#### PLAN COMMISSION MEETING AGENDA Thursday, June 6, 2024 at 6:00 P.M.

## CITY OF FRANKLIN REPORT TO THE PLAN COMMISSION

RESOLUTION NO. 2024-\_\_
A RESOLUTION APPROVING A SITE PLAN FOR LAKE GROVE PLACE,
A MULTI-FAMILY RESIDENTIAL DEVELOPMENT
(3709 W COLLEGE AVENUE)
(SAFARI HOMES FRANKLIN LLC, APPLICANT)

RE: Staff comments for Special Use and Site Plan, Lake Grove Place by Safari Homes

L 1.0

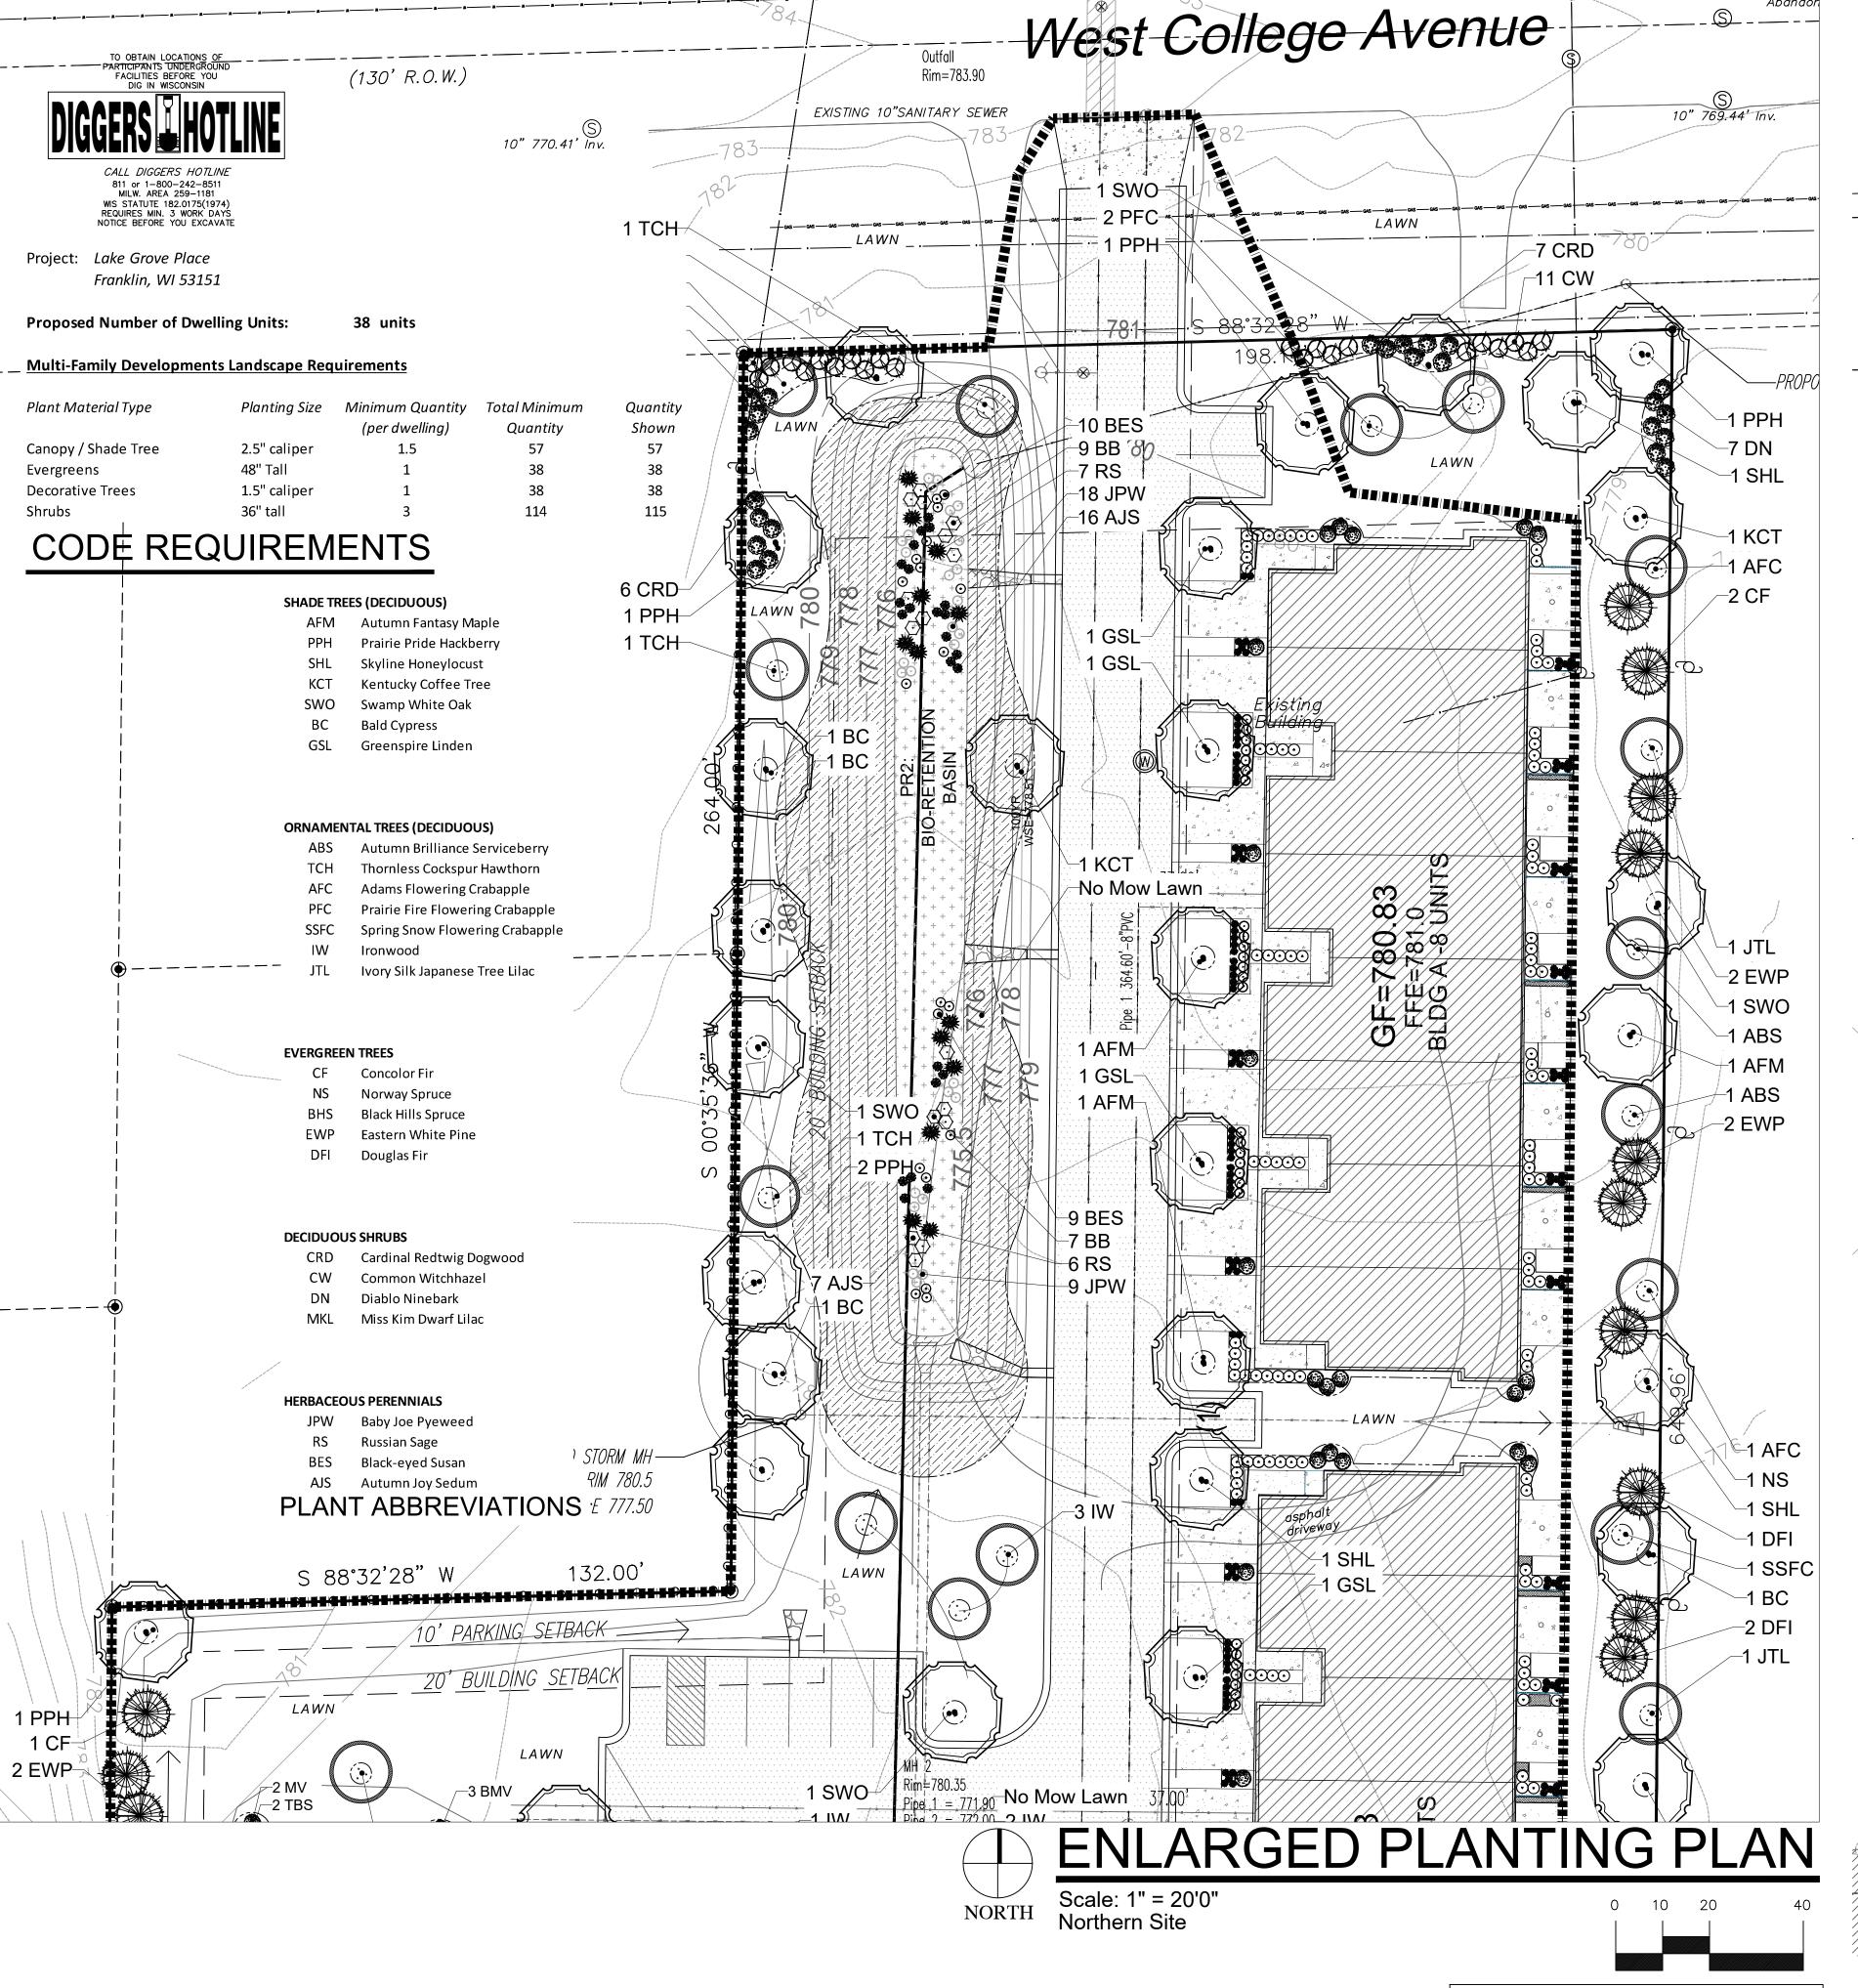
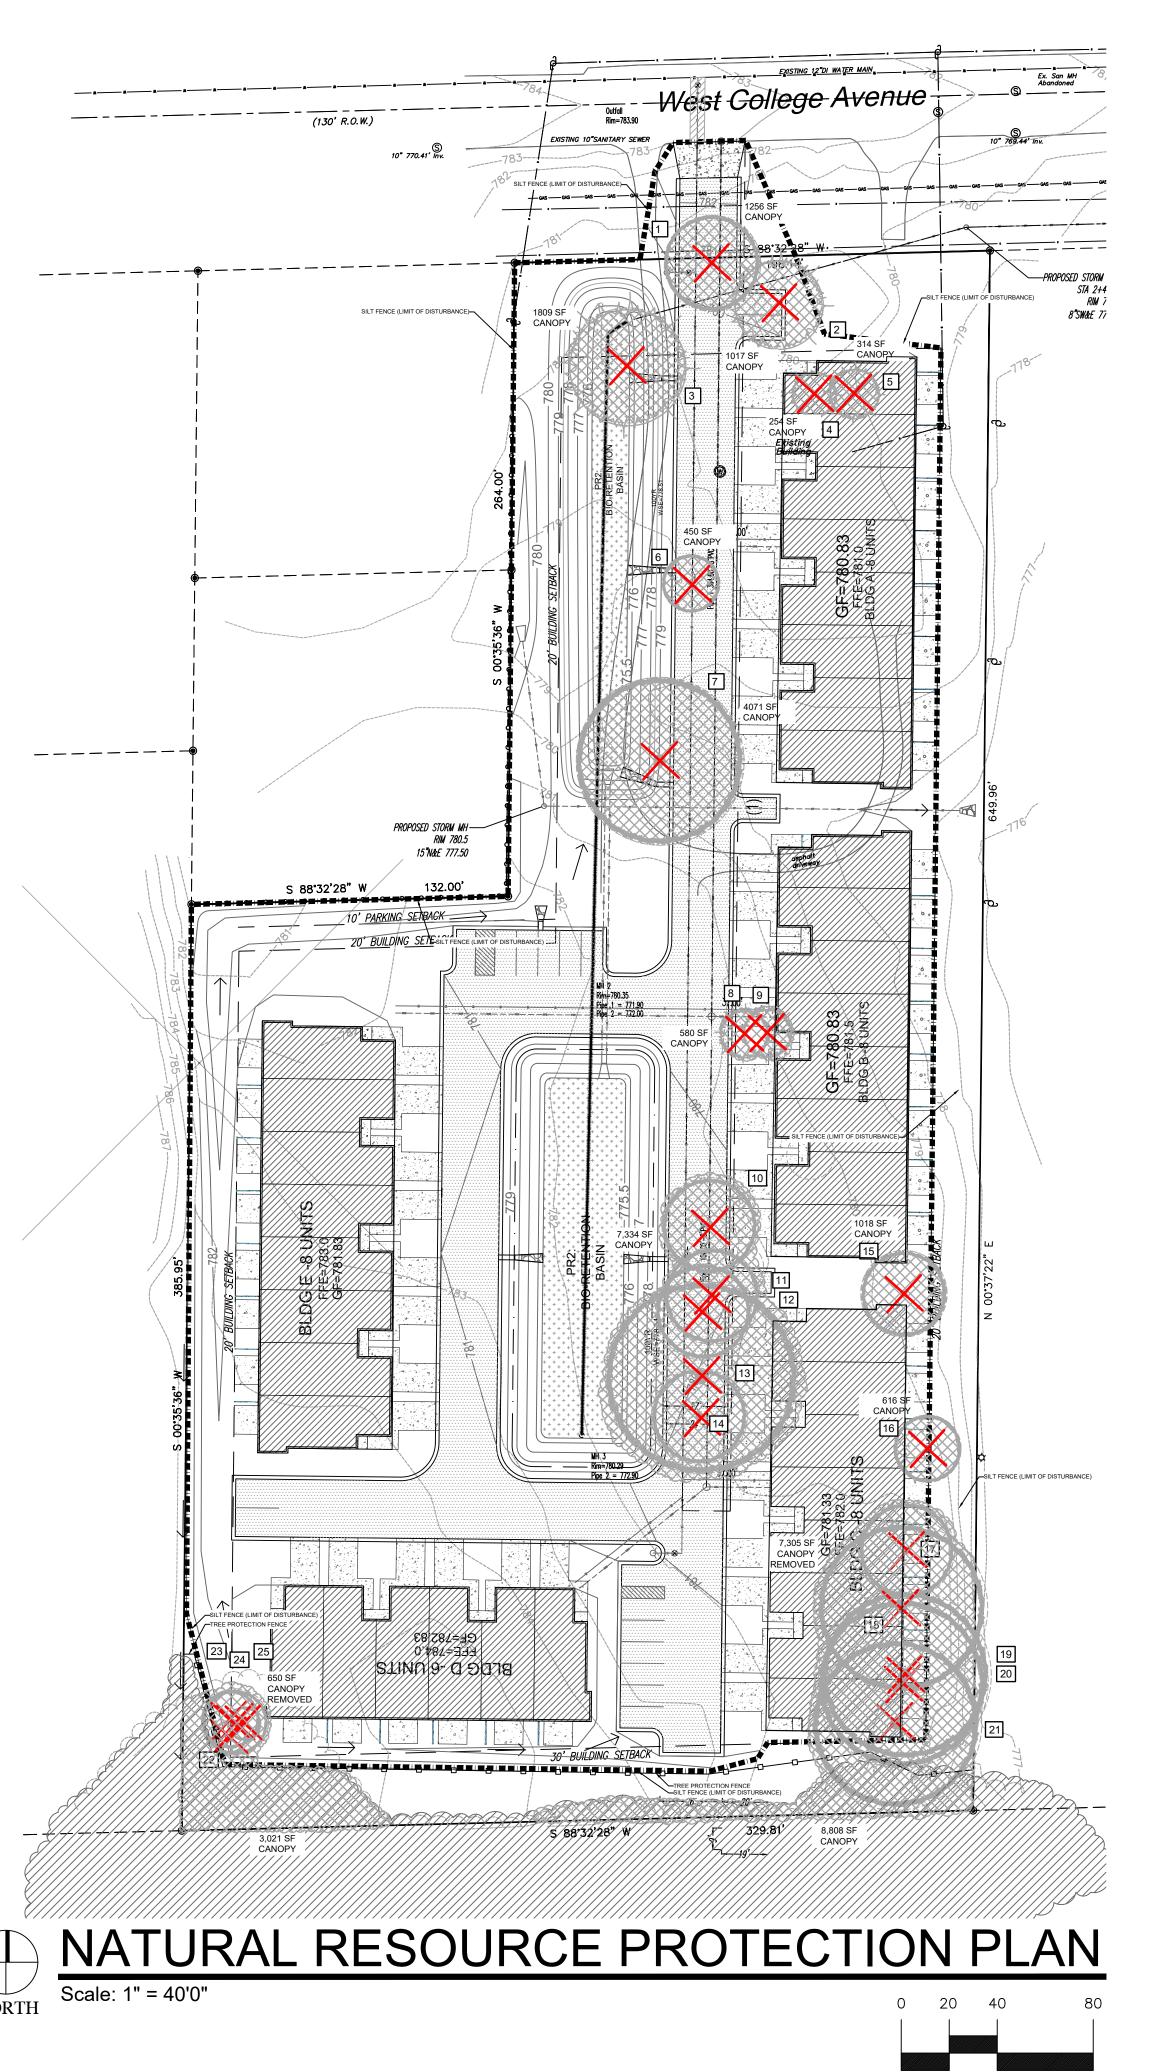
**Woodlands & Forest:** As depicted on the NRPP (Sheet L1.0 of the Landscape Plan submittal), there are no areas of vegetation that meet the definition of Mature or Young Woodlands, as outlined in the Franklin Zoning Ordinance.

Futher, Table 15-3.0503 "Worksheet For the Calculation of Resource Protection Land" has been added to the plan sheet L1.0 (Natural Resource Protection Plan) for this project, with a revision date of January Should you have any quesions on any of these materials, I would be happy to speak with you personally.

SHEET NUMBER C000

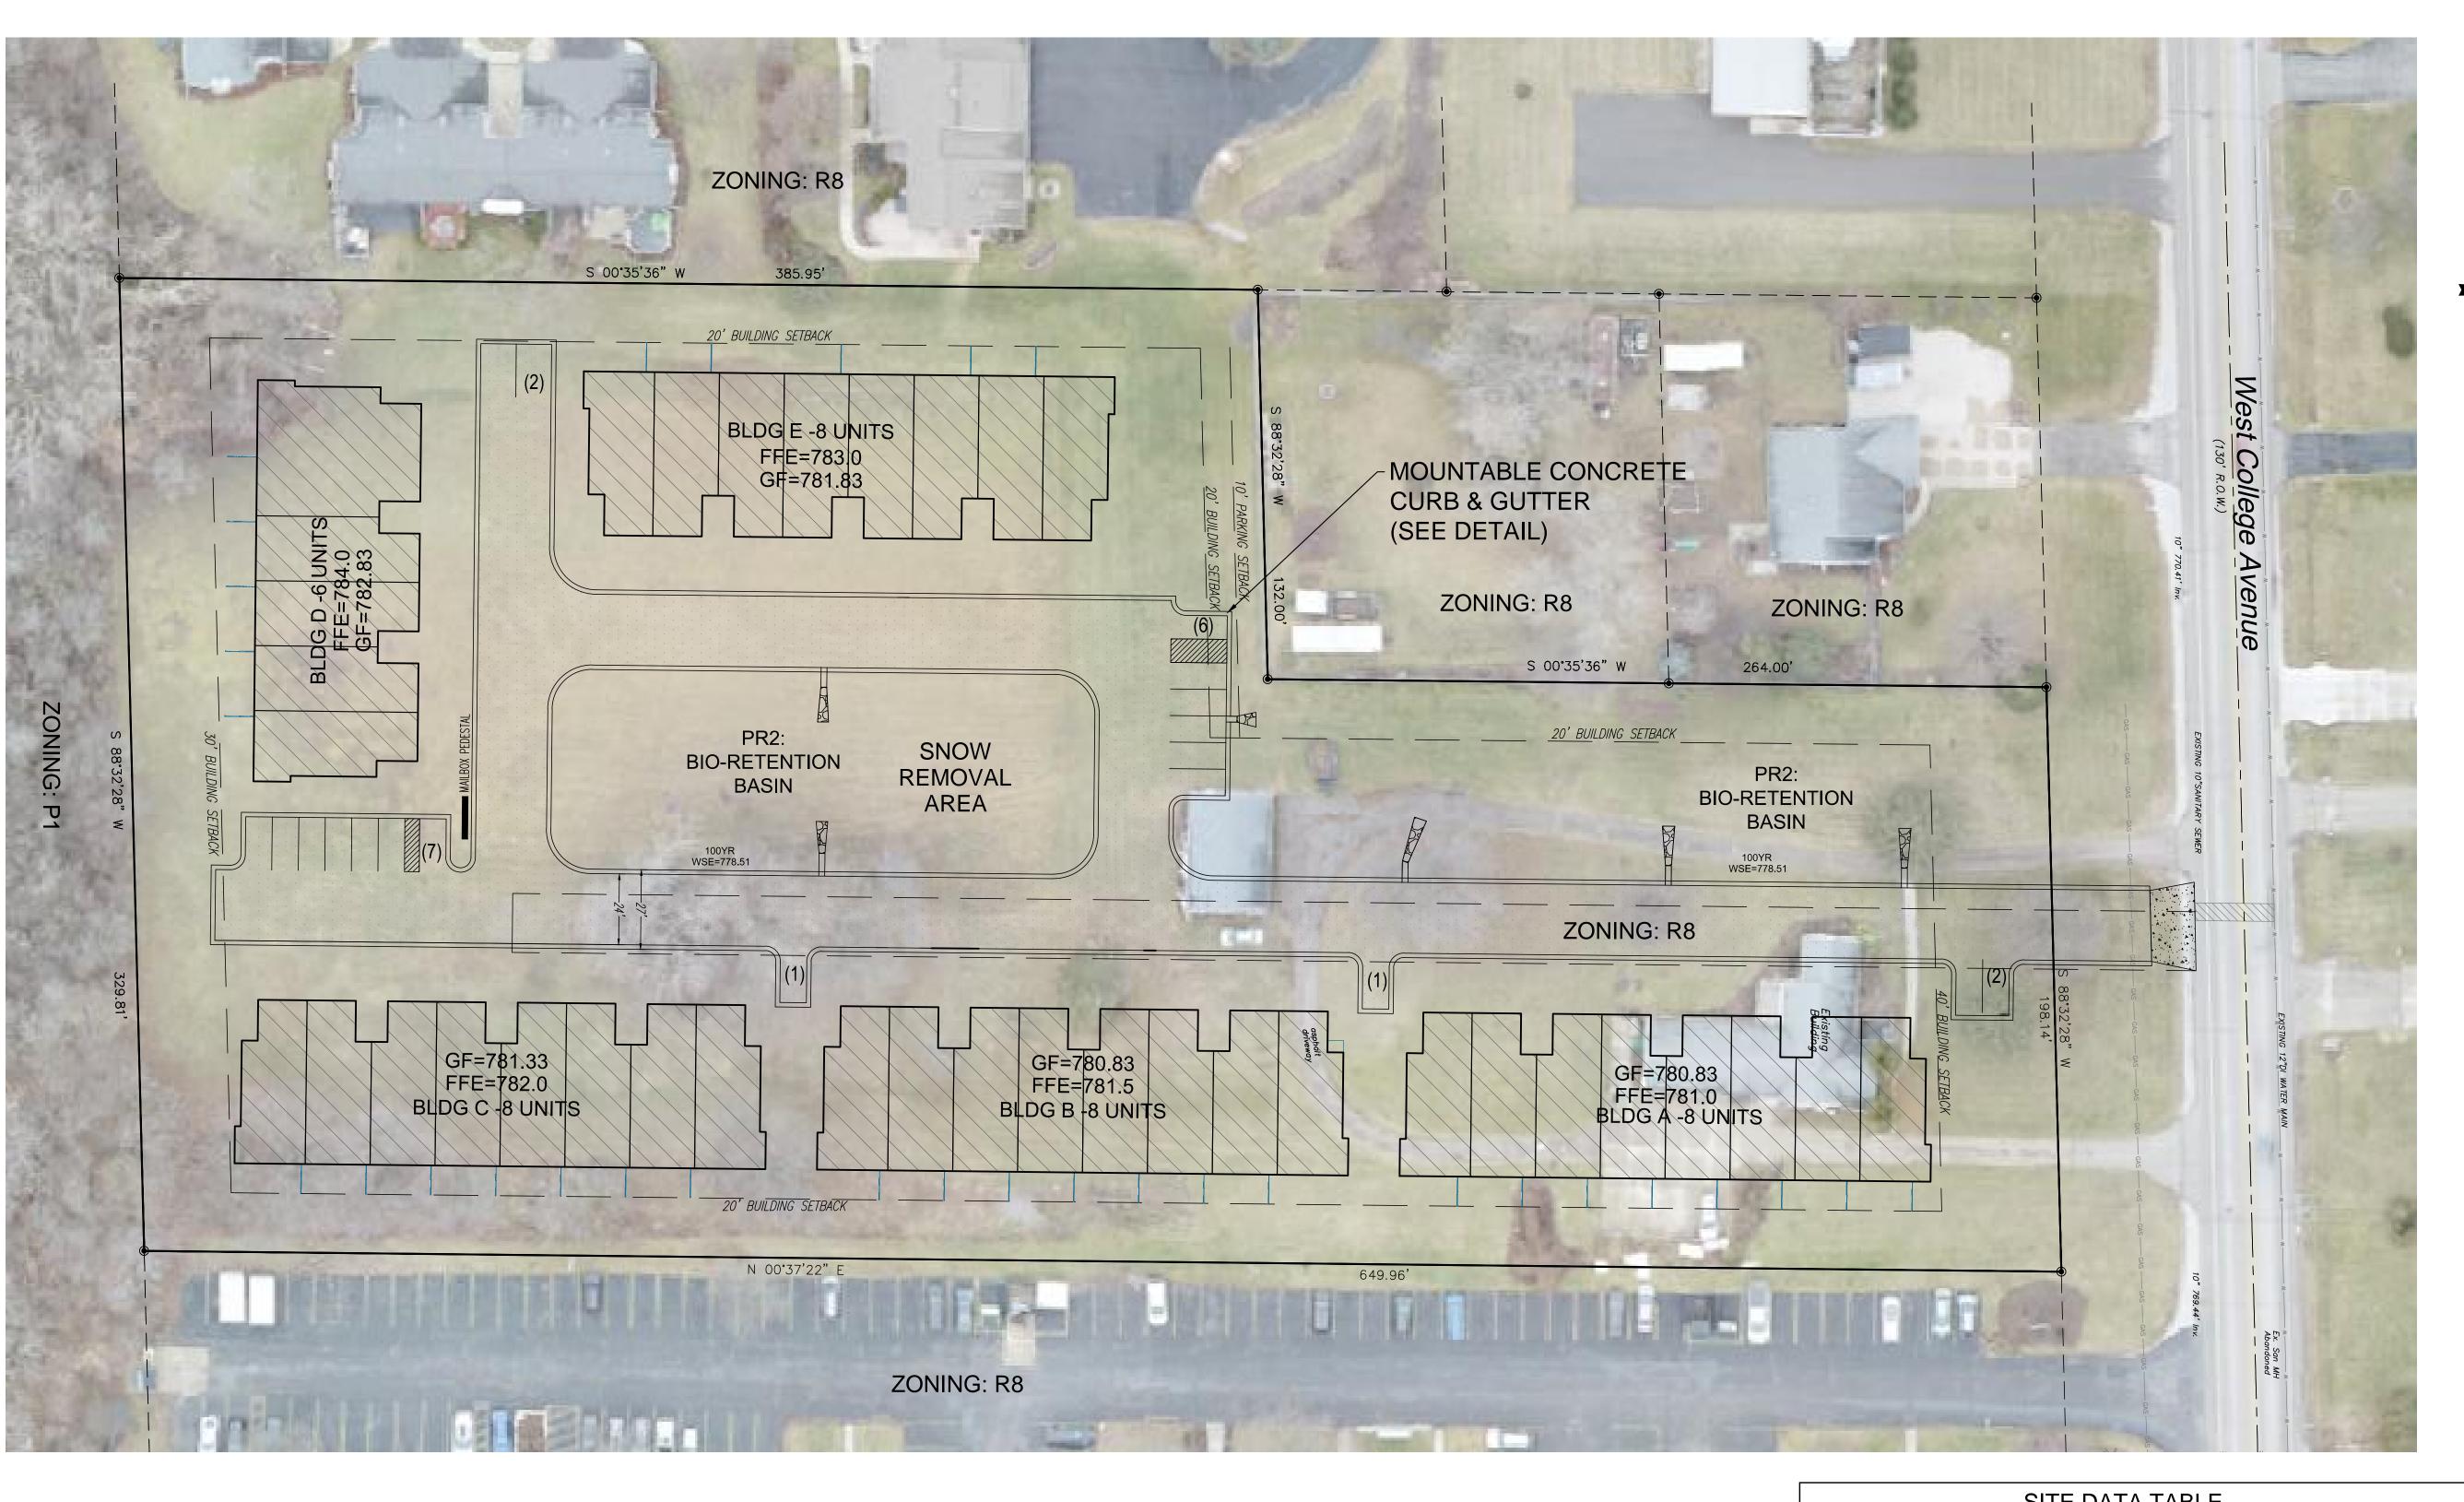
- E. Site size. Please add site size in acres to sheet C100. DONE
  - Note that the site size in the Site Plan must match the site size in the Site Intensity and Capacity Calculations, please revise accordingly. SITE IS 4.12 ACRES

- Z. Existing zoning. Please label zoning district of the subject property and adjacent properties (sheet C100). DONE
  - Please delete duplicated label from building A (sheet C100). DONE

3. Parking space size. Please add dimensions of typical parking space size. The proposed parking spaces are 162 square feet (9 x 18 feet). The minimum parking space size is 180 square feet per UDO §15-5.0202B, please revise accordingly. DONE
